10 January 2022

BLM Office Renovations
Pearl Public School District – Pearl, MS

ADDENDUM NO. 01

E000
ELECTRICAL
LEGEND

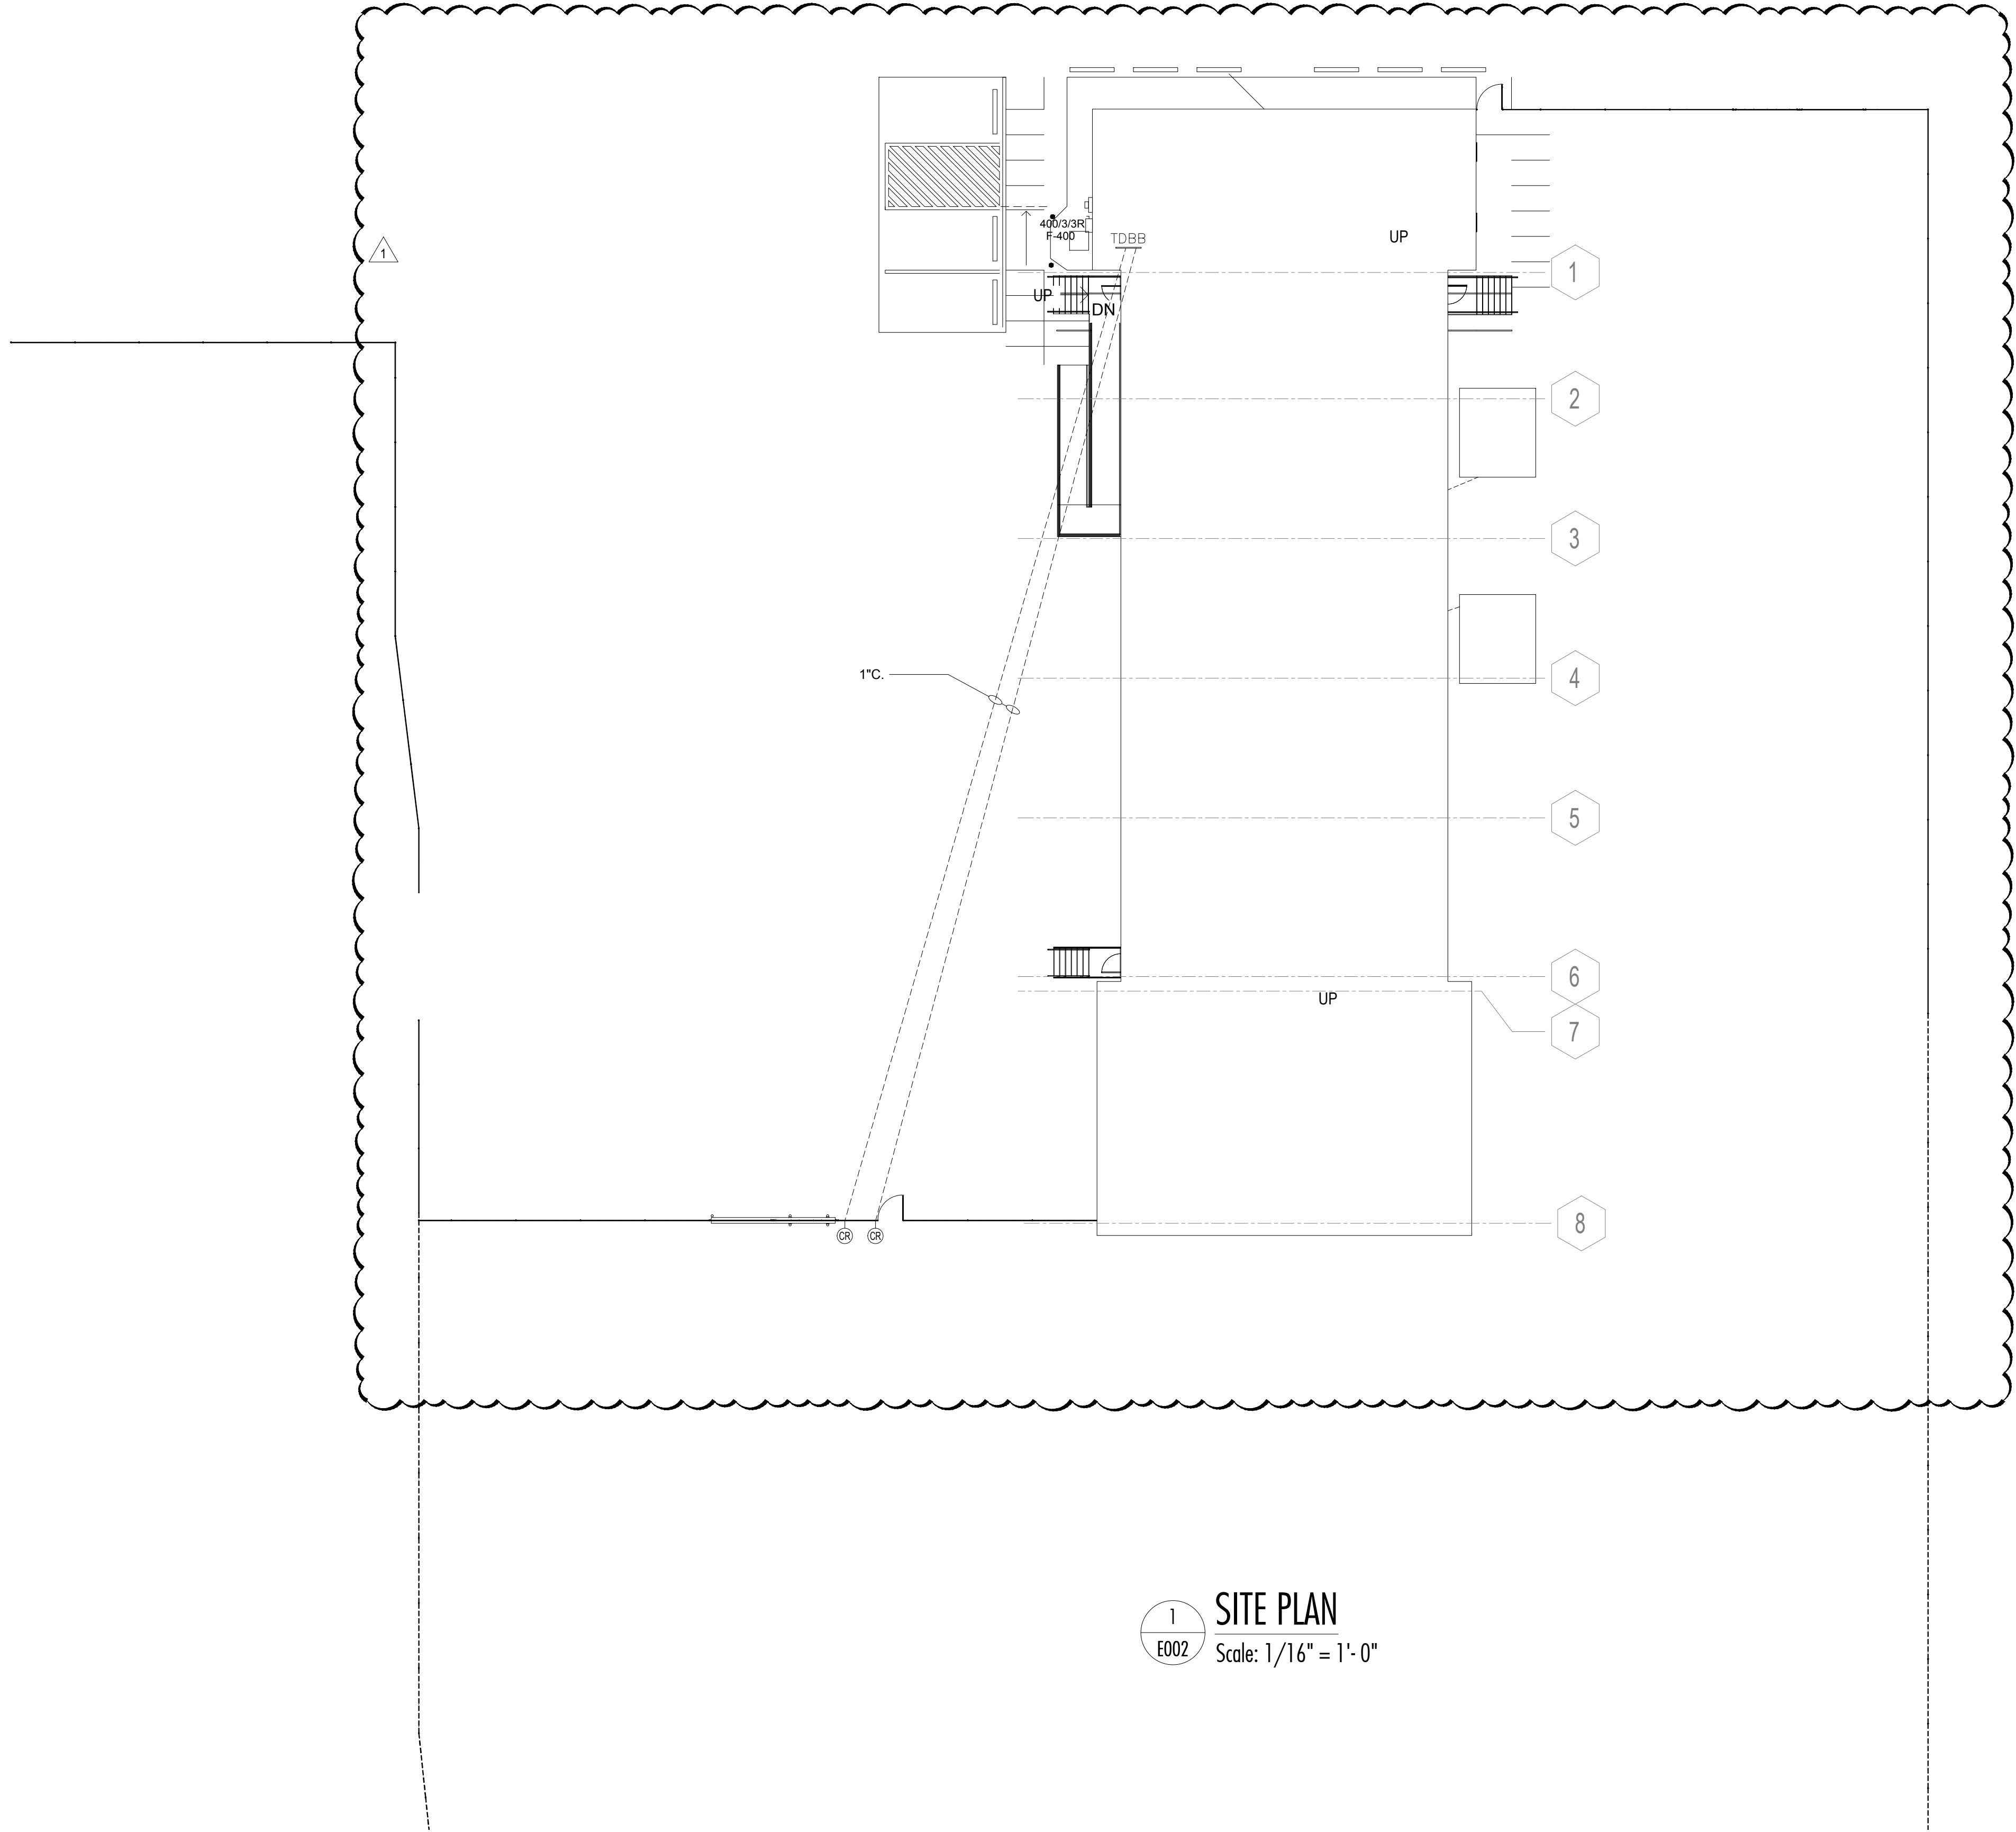
ITEM NO. 14 E000 ELECTRICAL LEGEND
ED100 DEMOLITION PLAN
E100 LIGHTING PLAN
E300 POWER PLAN
Revise per the enclosed sheets.
